LINCOLN PARK PLANNING COMMISSION
SPECIAL MEETING
December 17, 2020 at 6 p.m.

3387 Fort – Plumbing Contractor

Site Plan Review

Applicant	Tracey Yarbrough
Project	Plumbing Contractor
Address	3387 Fort Street, Lincoln Park, MI 48146
Date	December 17, 2020
Request	Site Plan Review
Recommendation	Approval with Conditions

sheet title:
Exterior Elevations

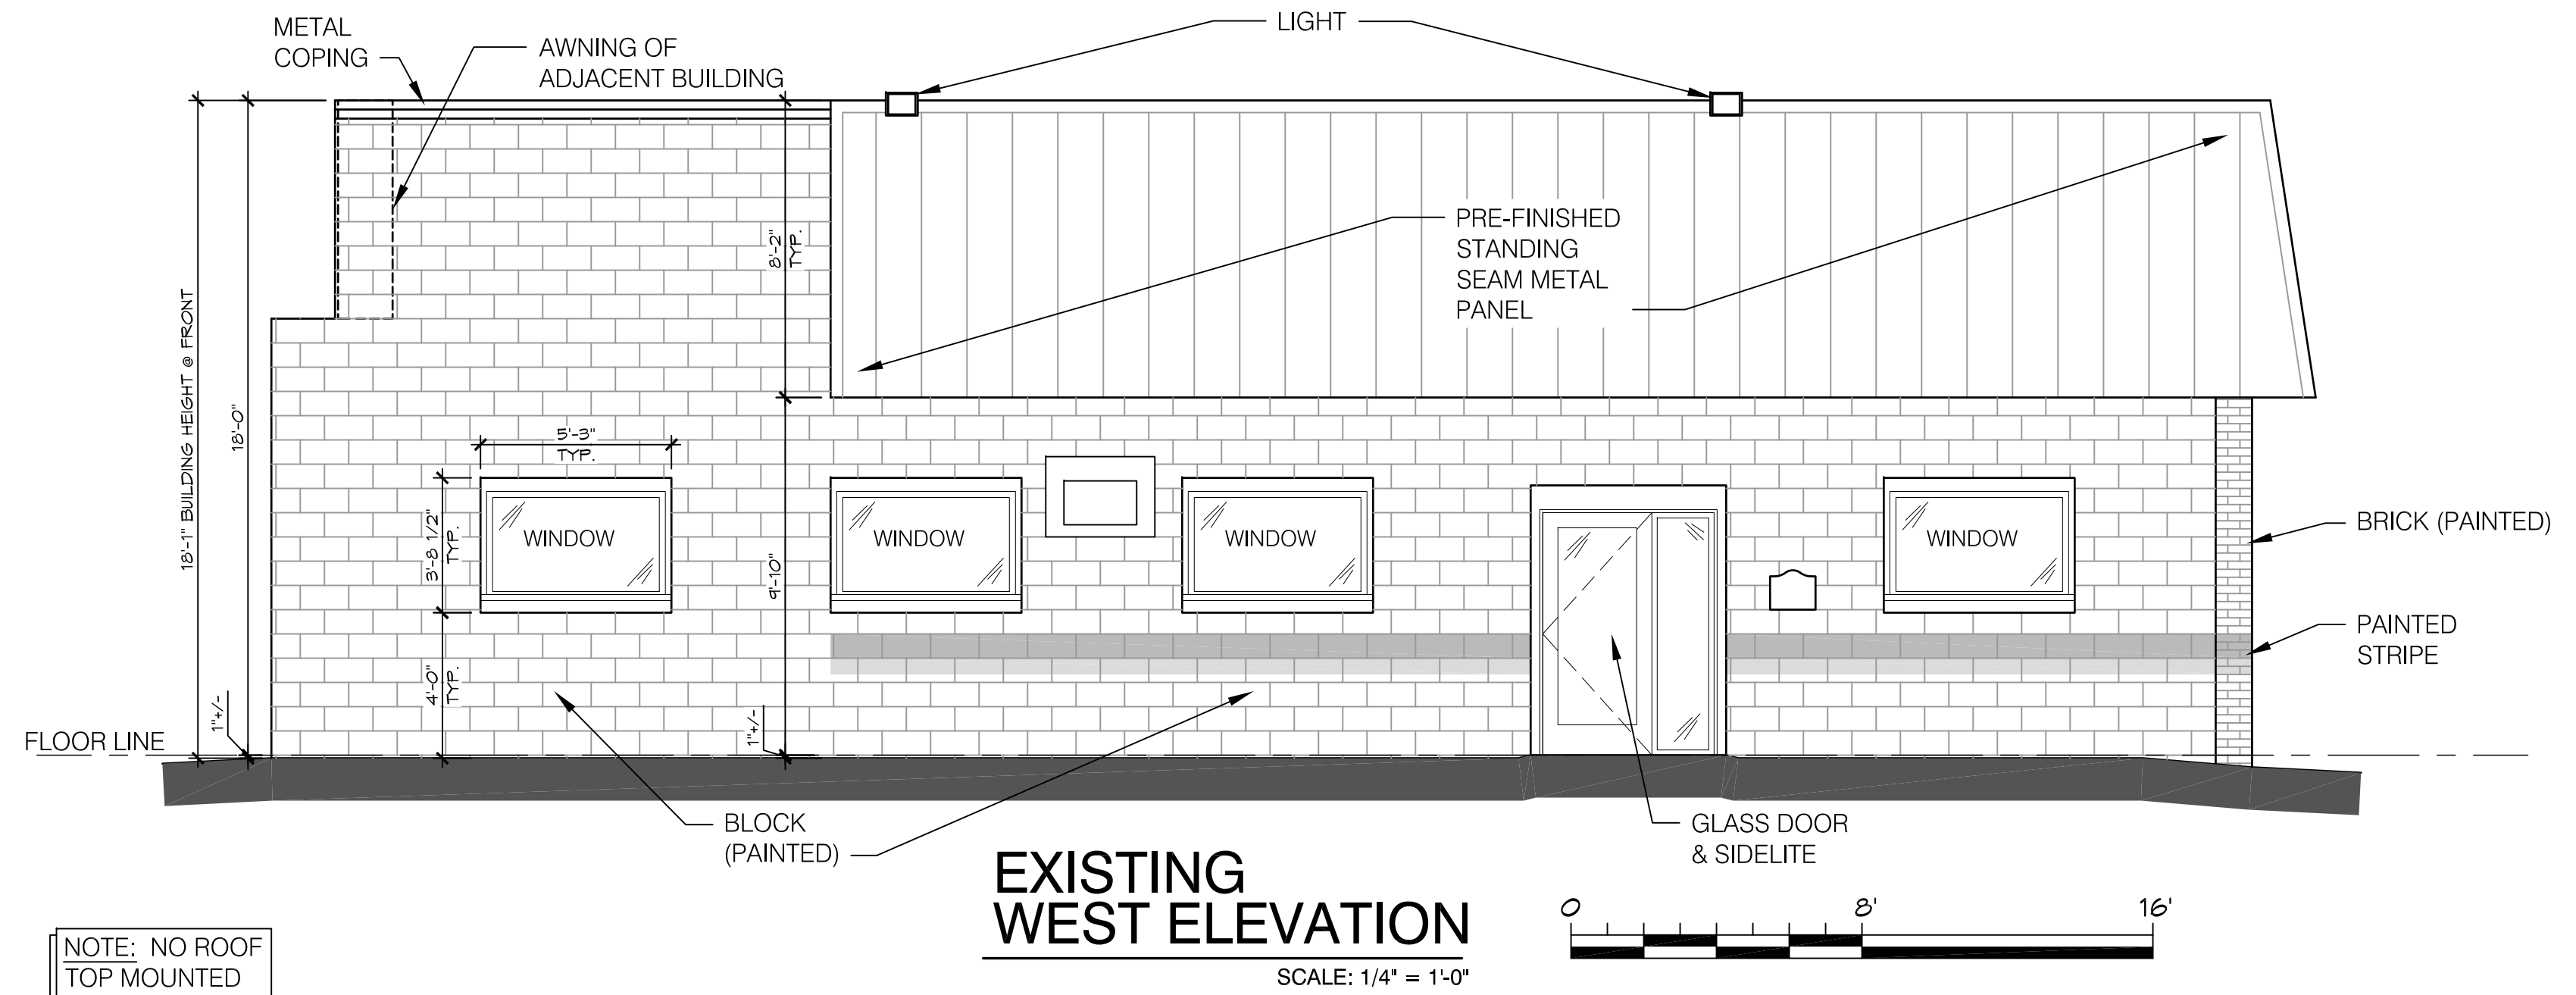
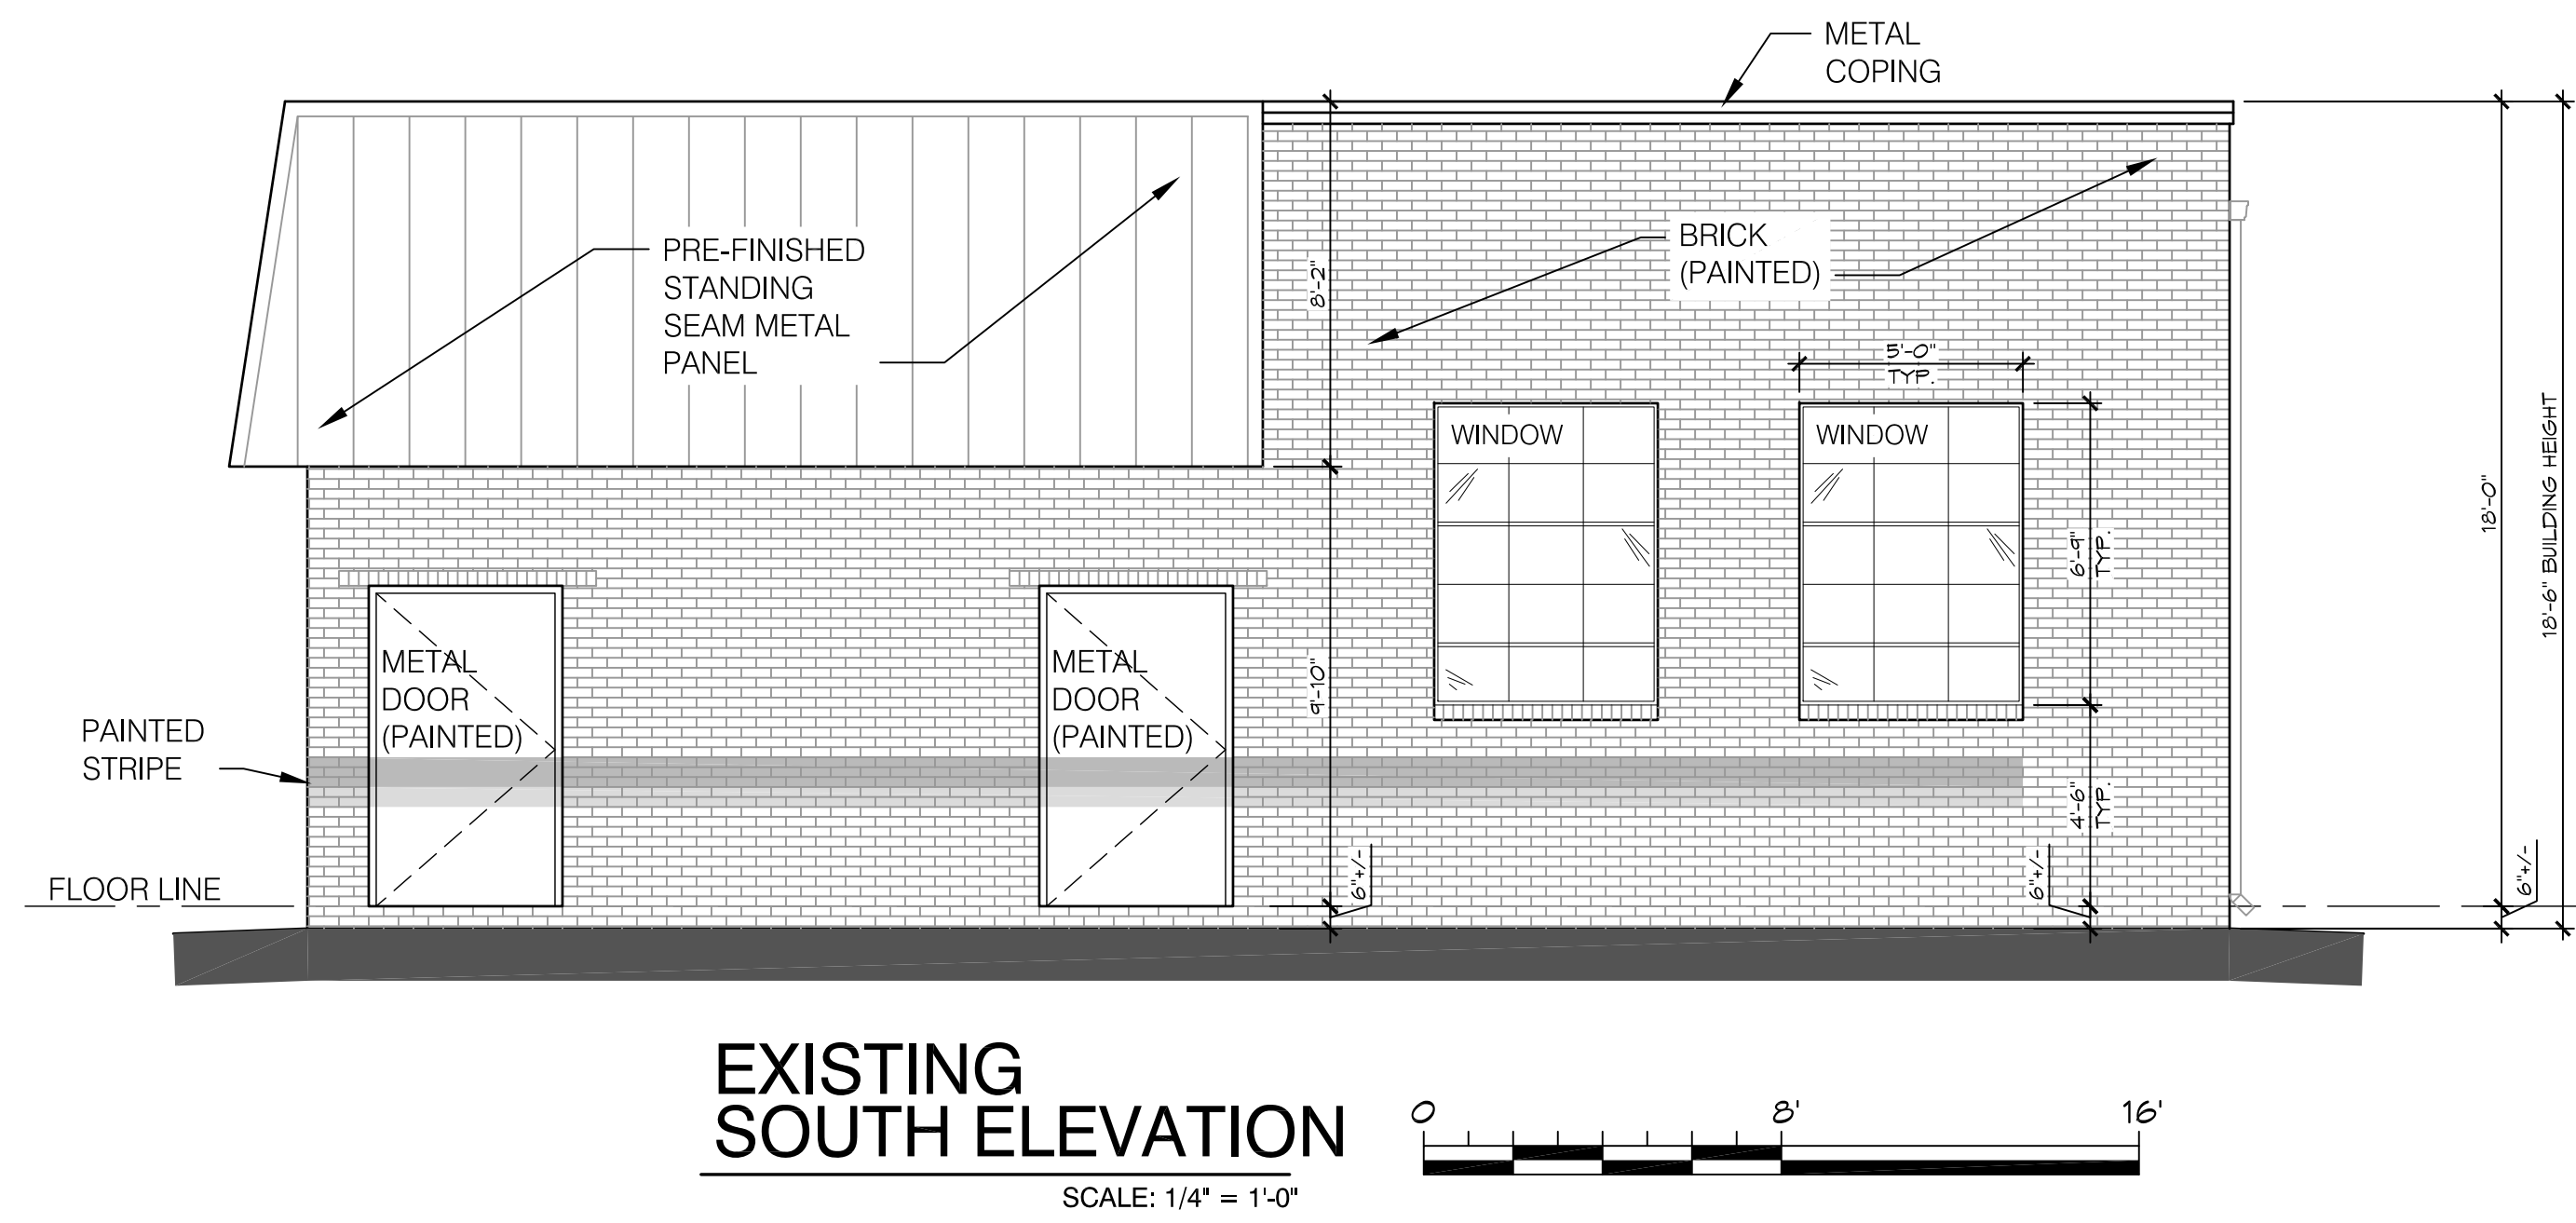
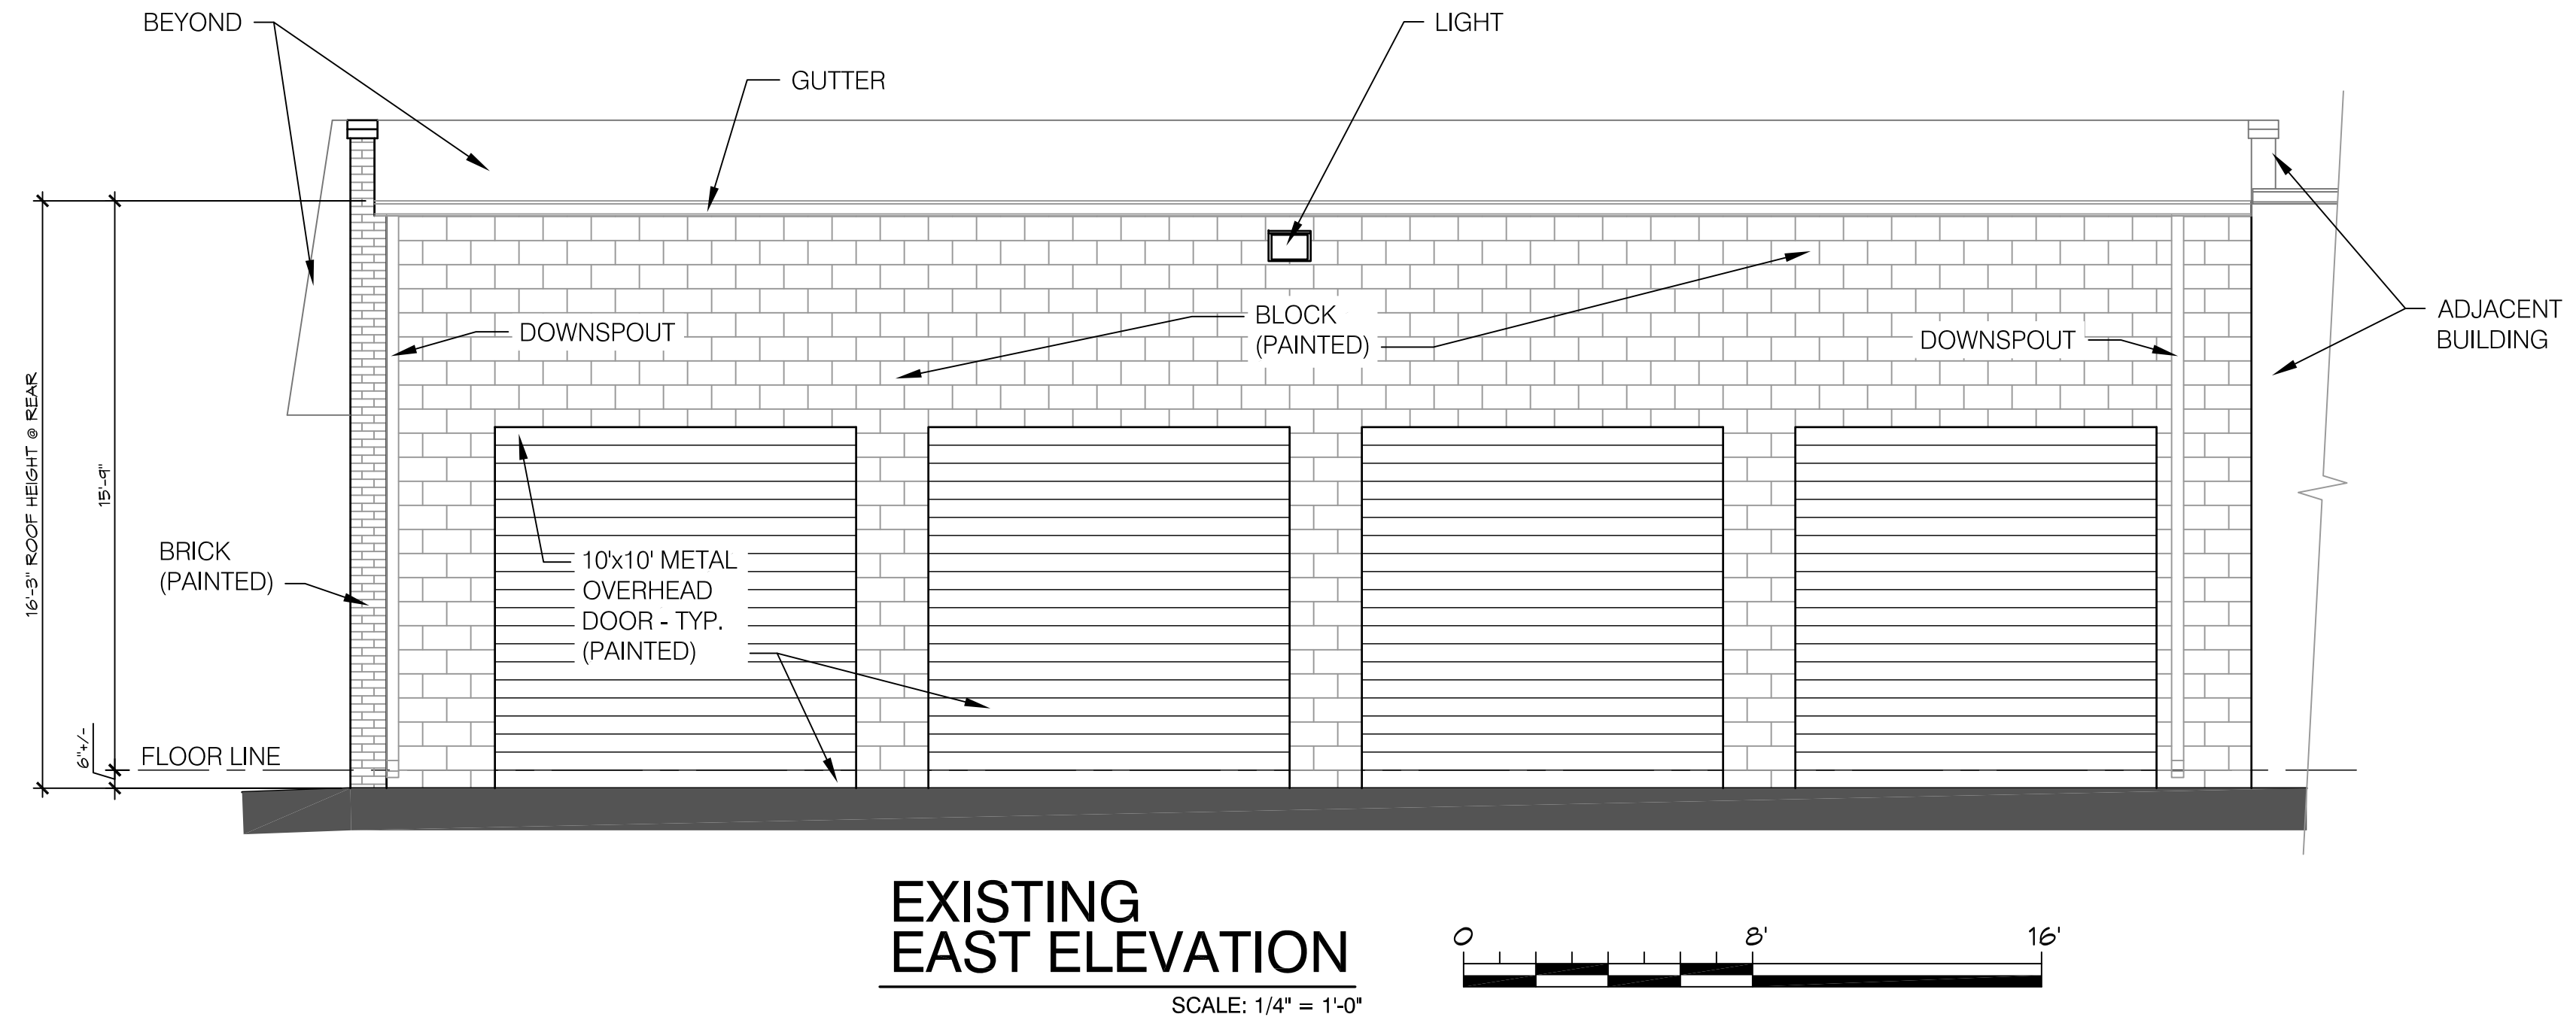
The existing building does not meet the standards for transparency or building materials. As the proposal does not include changes to the building façade, the City has historically permitted existing façade conditions to remain.

There are two existing lights on the front façade of the building located on the roof line, and there is one existing light on the rear façade of the building located above the garage doors. The applicant has indicated that there will be no change to the existing lighting. The existing lights on the front façade of the building appear to be shielded and directed away from Fort Street. The existing light on the rear façade of the building appears to be pointed downward; however it does not appear to be shielded.

- *Applicant shall ensure that lighting is arranged to reflect away from adjacent properties and so that it does not impede the vision of traffic along adjacent streets.*
